Electrical Distribution Box Wiring

The PC6024 is an APU only system with a power distribution box. There is a possibility that the connections to the GFCI outlet inside the box may be incorrectly wired.

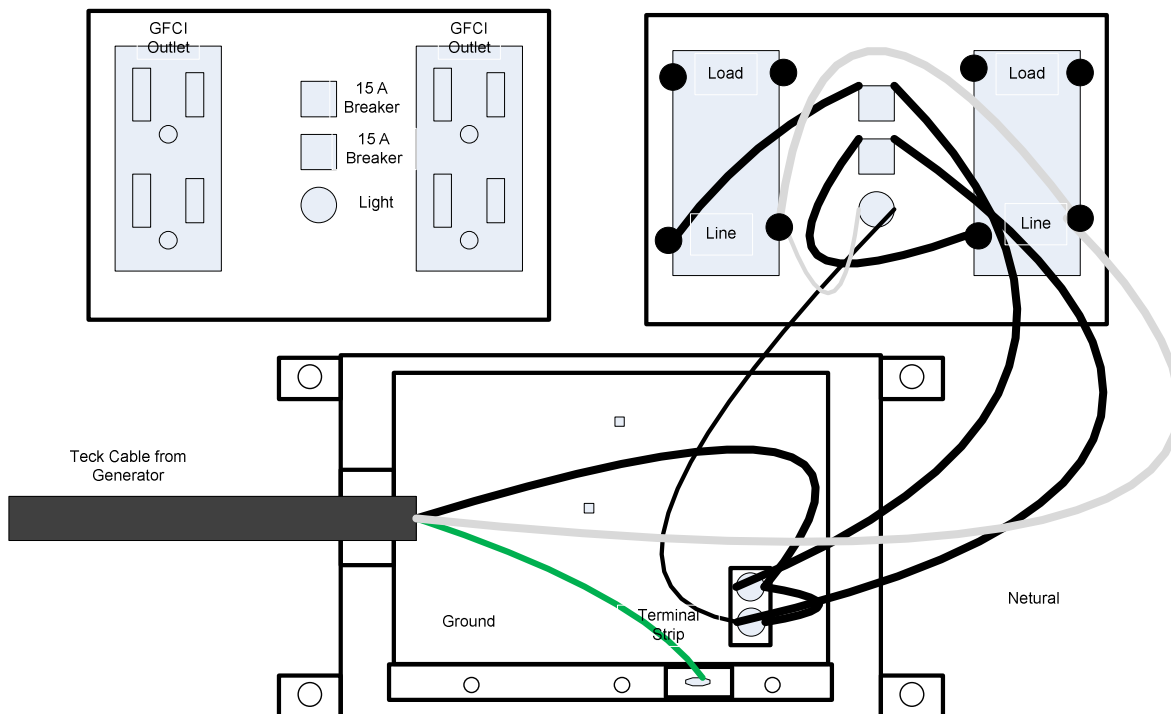
The GFCI outlet has 2 pairs of terminals. One pair is labeled "LINE" and the other is labeled "LOAD". During installation of the PC6024, the box must be opened to connect the teck cable. At the same time the wiring to the GFCI outlets should be verified.

A properly wired outlet will have the wiring connected to the LINE terminals.

If the wiring is incorrect, move the wiring to the correct terminals.

NOTE: for each outlet, the Black wire should go to the gold terminal and the white to the silver terminal. The lead to the indicator light should also move with the white wire.
